Year 4 Monitoring Report FINAL

Hudson Property

DMS Project ID #: 95361

RE: Draft Year 4 Monitoring Report for Hudson Property Stream Restoration Project (95361)
Tar-Pamlico River Basin; CU 03020105; Beaufort County, NC
Contract No. 004638

Figure 10

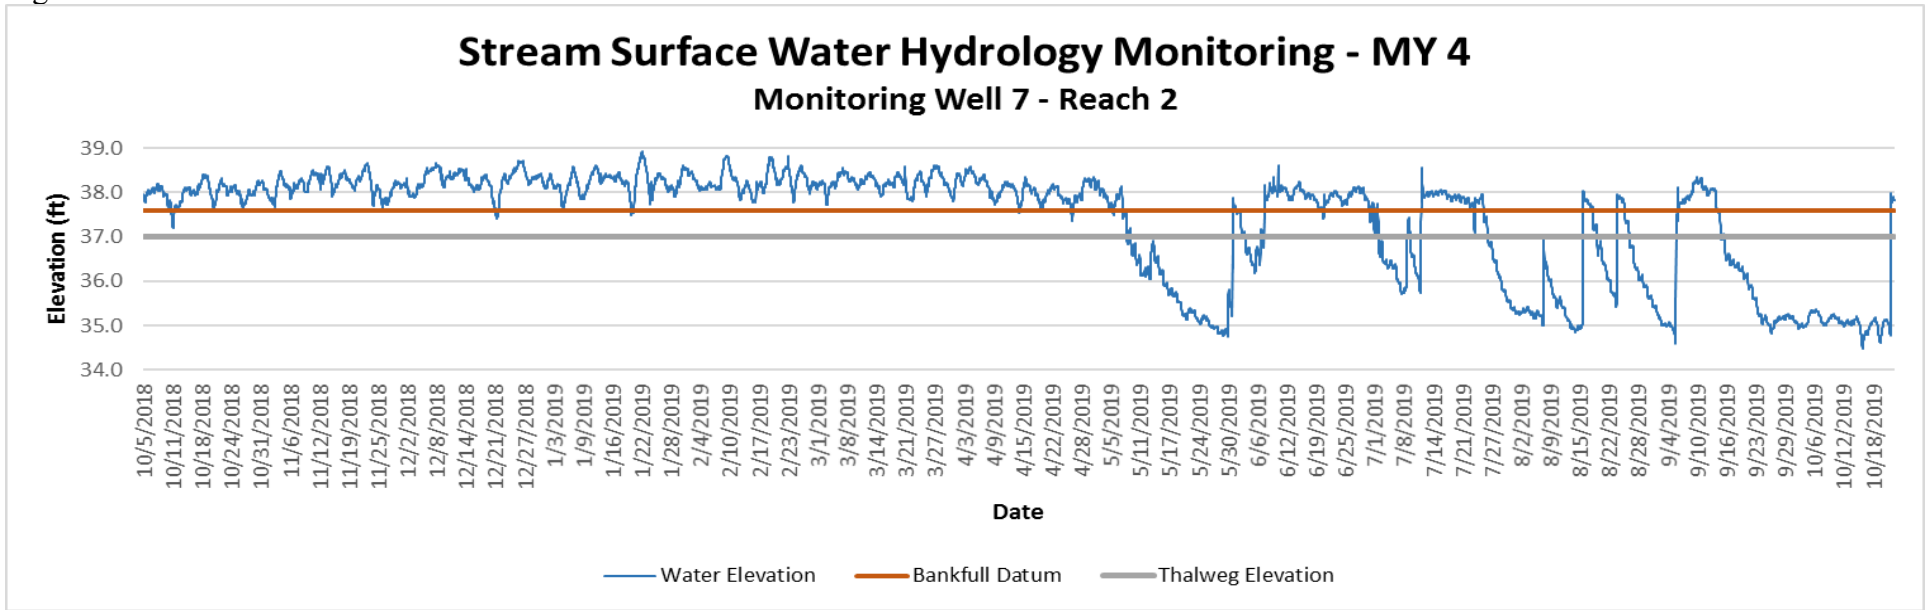
c. Figure 10 – See "b" above. Please verify that Well 8 (Reach 5) achieved 30 consecutive days of flow. It may be beneficial to call out with arrows and dates on the chart where 30 consecutive days was identified.

ECOTONE RESPONSE: Table 9 has been updated to include previous years' data. Well 8 on Reach 5 did have 30 consecutive days of flow. Though water occasionally dropped below the streambed elevation for a few hours, each day between 1/21/19 and 3/21/19 did have some flow. Figure 10 was updated with a note to identify that period of consecutive flow.
